Re: Docket No. 516 – The United Illuminating Company Application for a Certificate of Environmental Compatibility and Public Need for the Fairfield to Congress Railroad Transmission Line 115-kV Rebuild Project

Enclosed for filing with the Connecticut Siting Council (“Council”) are The United Illuminating Company’s (“UI”) Late Filed Exhibits as requested by the Council during the August 29, 2023 hearing.

Late Filed Exhibit 2-3

Q LF-2-3: Provide a drawing for Structure P724S that depicts its location, including the locations of the work pads, the aerial easement and the pole installation easement:

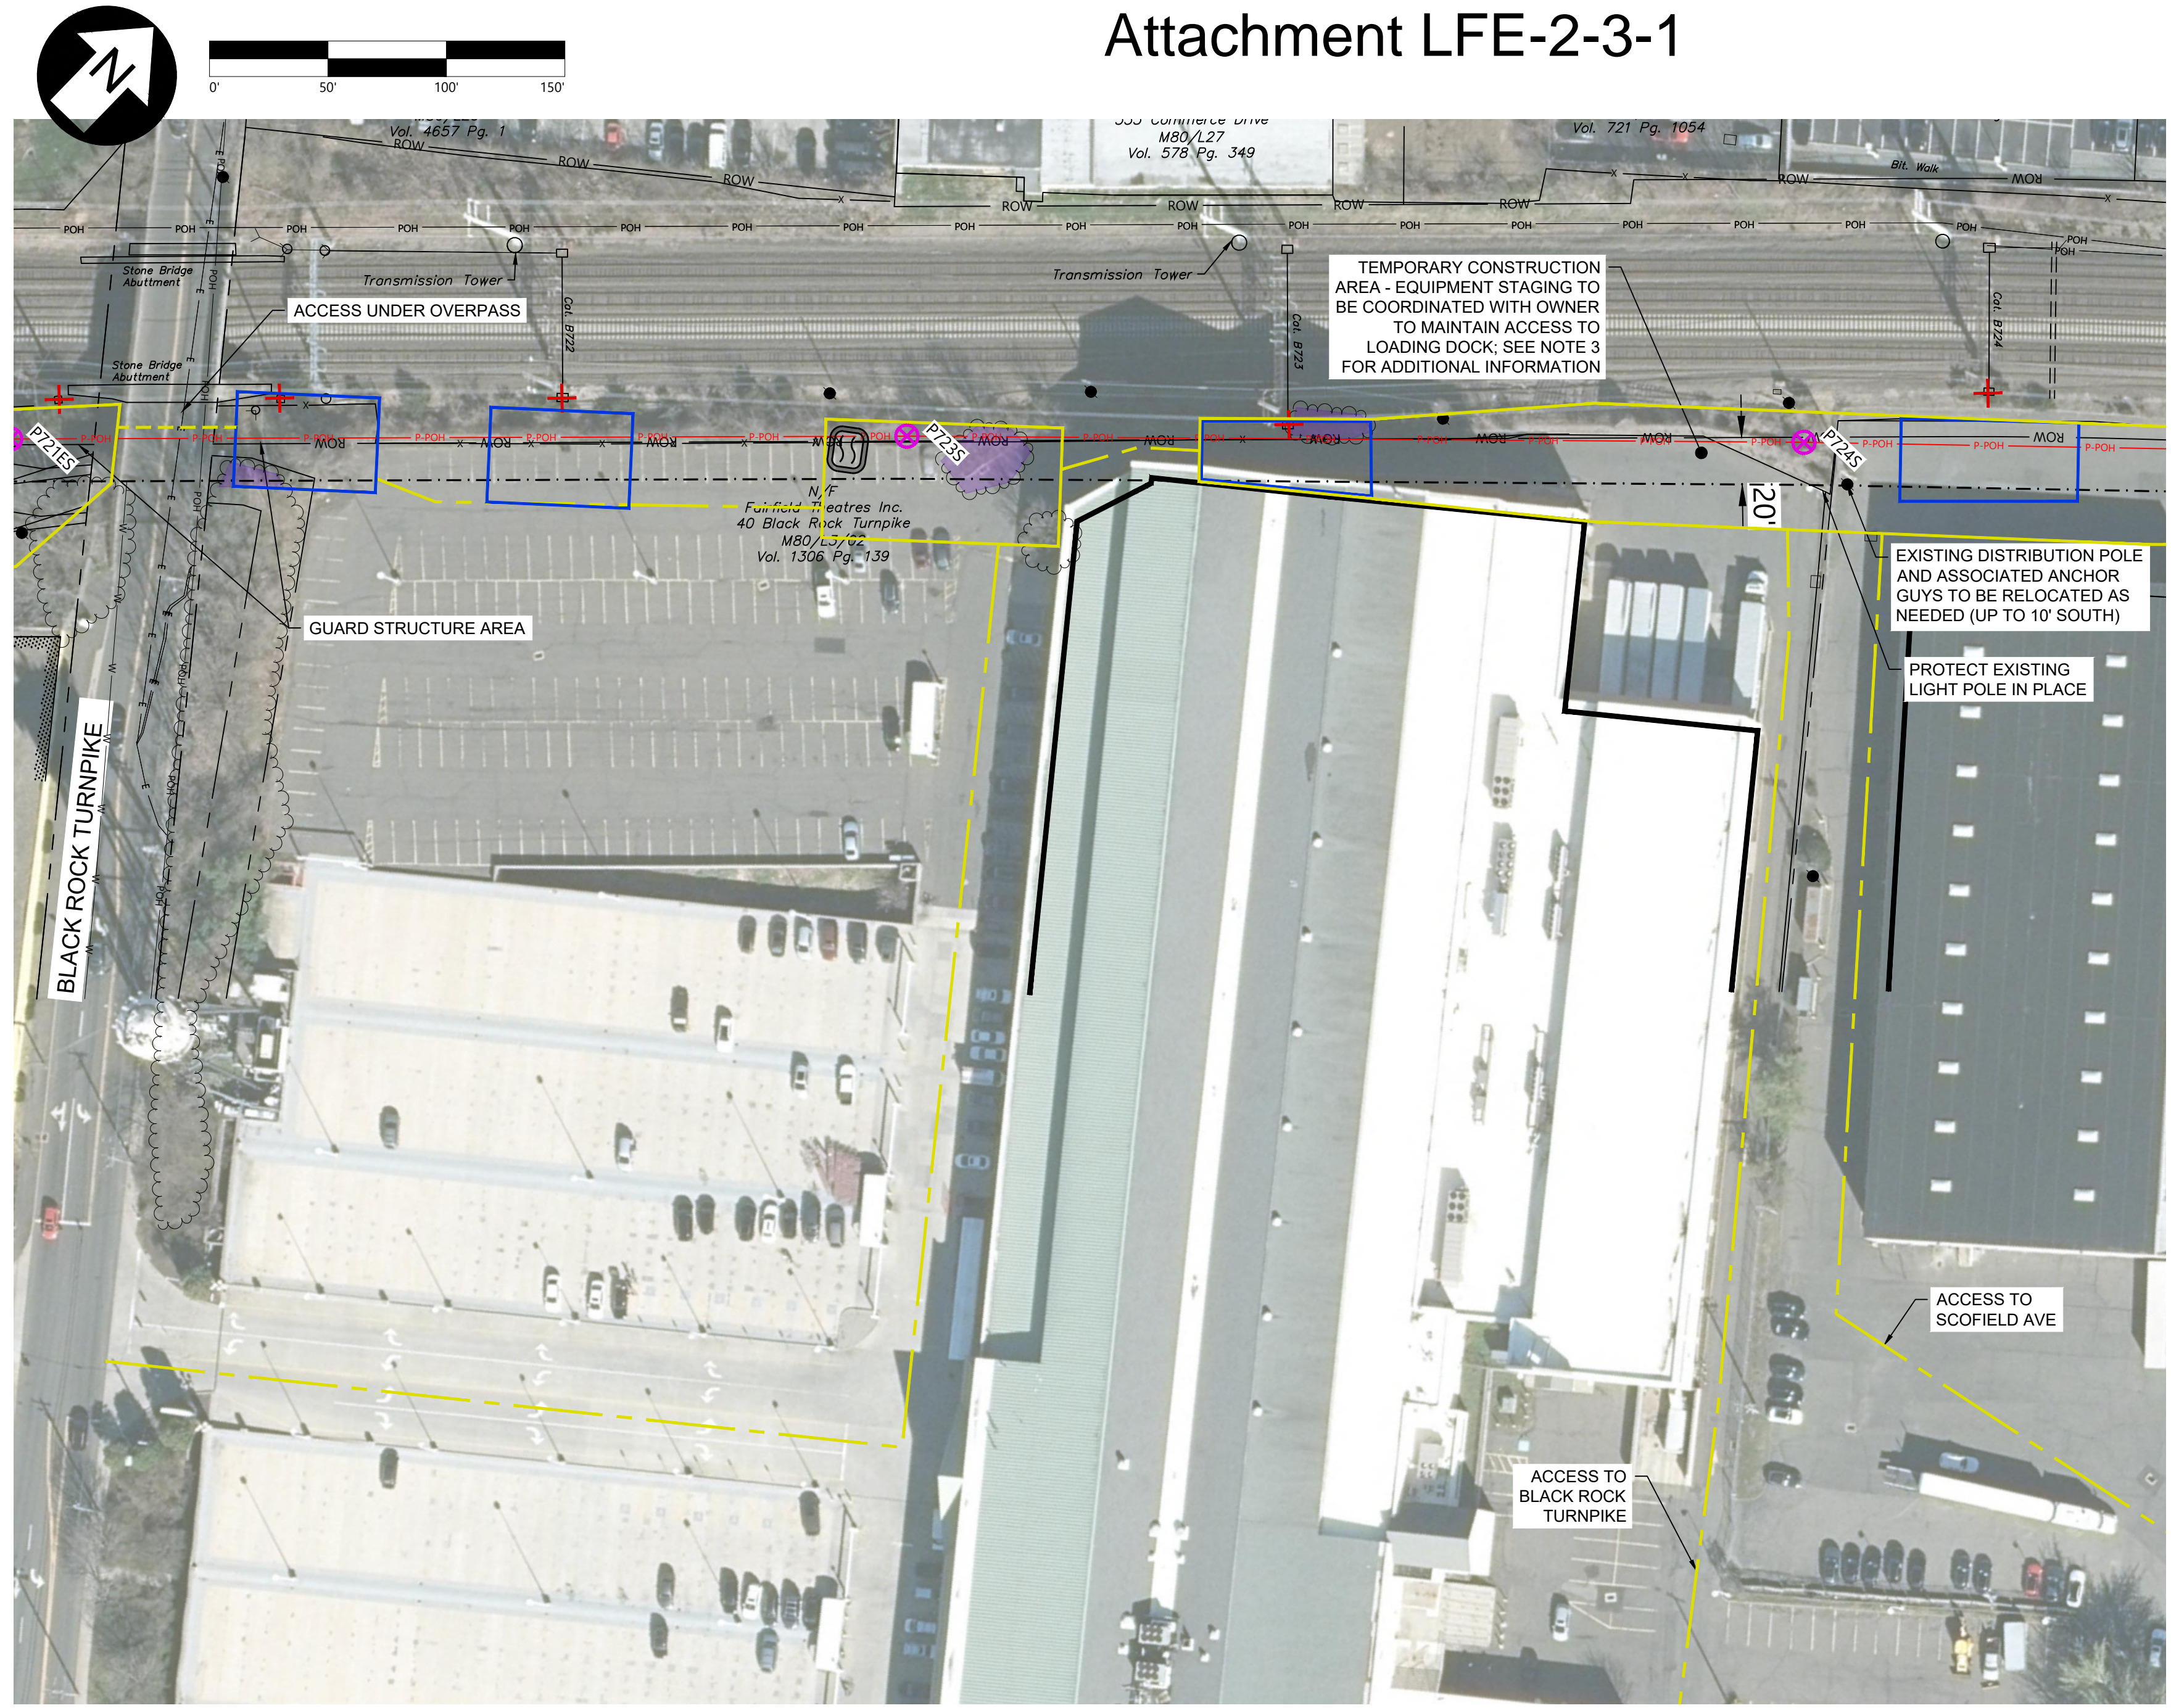
- a. In the application;
- b. In Configurations 2-1 and 2-2;
- c. In Configurations 2-3 and 2-4; and
- d. In relation to the BWC easement.

- a. See Attachment LFE-2-3-1 A for the location of P724S, work pads and permanent easement width at P724S. The temporary (pole installation) easement is contiguous with the work pads where the work pads are located outside of the permanent easement.

- PROPOSED POLE LOCATION:** THE ORIGINAL DESIGN IN THE APPLICATION PLACES THE POLE AND FOUNDATION FULLY ON THE BWC PROPERTY IN A GRASSY AREA THAT IS ADJACENT TO THE CTDOT RAILROAD CORRIDOR AND SEPARATED FROM THE USED, PAVED AREA BY BOLLARDS. PER THE DESIGN IN THE APPLICATION, THIS STRUCTURE IS A DEADEND STRUCTURE ASSOCIATED WITH A LARGER PULLING PAD TO FACILITATE THE INSTALLATION OF THE NEW OPGW AND 115KV CONDUCTOR IN BOTH THE EASTERLY AND WESTERLY DIRECTIONS.
